**CARLETON PLACE ARENA  
ADDITION AND RENOVATIONS  
75 Neelin Street Carleton Place, Ontario**

**CIR #7 Detailed Summary**

CIR #07

## **SITE INSTRUCTION NO. ME-01** **MECHANICAL AND ELECTRICAL**

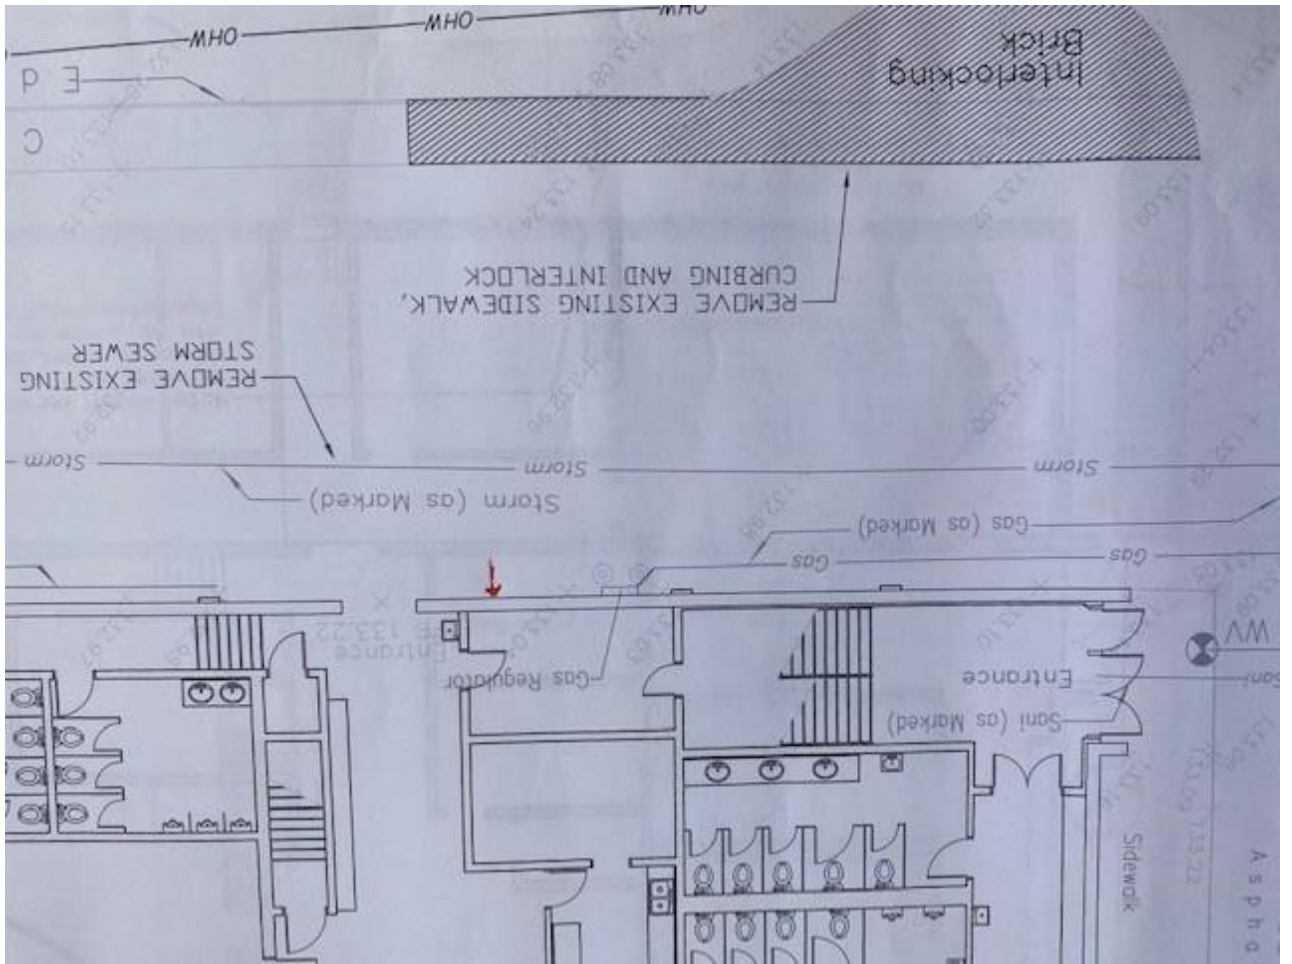
1. Please see two pictures below. One of what seems to be a storm pipe coming out from under the footing. The other picture is the location on R-1 marked in red. As per drawings, this pipe was not identified.

Please advise how to proceed.

Refer to attached sketch of storm drain prepared by Town of Carleton Place, with the following notes:

- Storm piping shall be 200mm to match existing;
- Supply and install cleanout at 90 degree turn, and at building exit.

New Roof Drains shall be deleted, as follows:

- 2 x 3" roof drains and 4" storm drain piping with insulation shall be deleted.
- Upper roof shall drain through scuppers, per the Architectural drawings.
